Memorandum

Project: Coneburn Industrial Zone
Subject: Landscape and Visual Effects
Date: 26/10/2021

Figure 2: QLDC Proposed District Plan Decisions Version Coneburn Structure Plan.

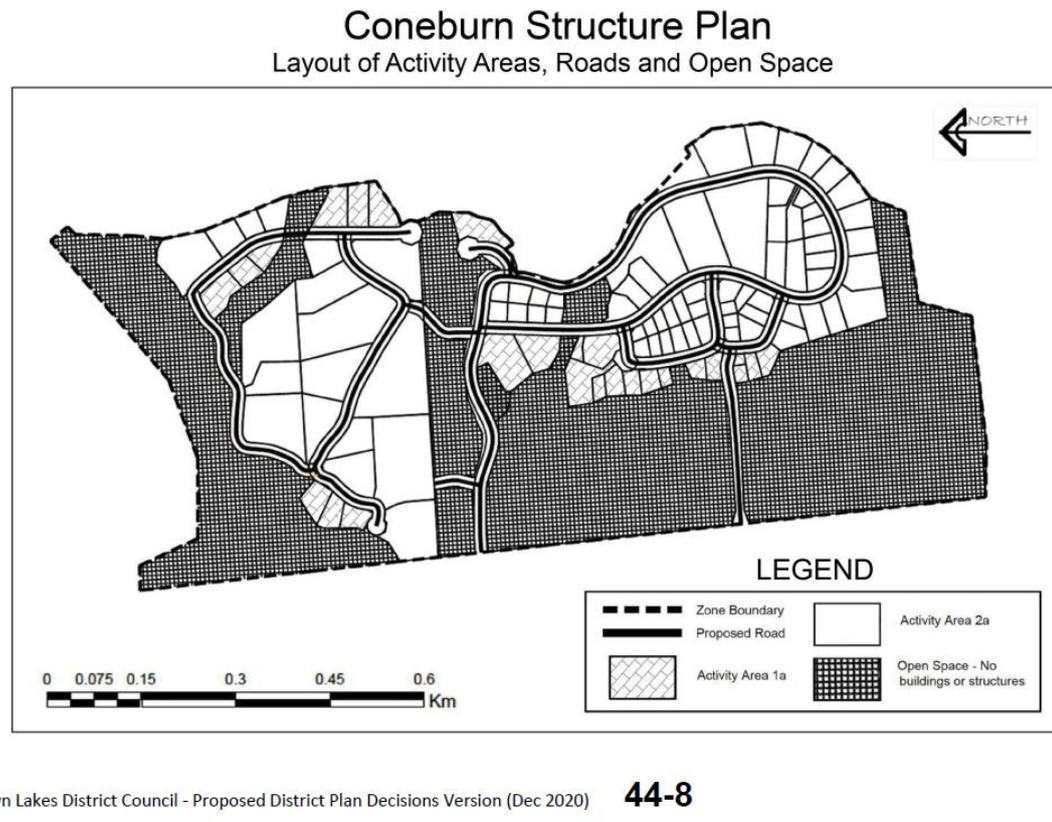
- 3.4 It should be noted that the DV Coneburn Structure Plan (**Figure 2** below) anticipates *Open Space - No buildings or structures* land use within this part of the Coneburn Industrial zone. Therefore, amending the UGB or ONL boundaries to better align in the part of the zone will not impact on the potential for development within the zone.
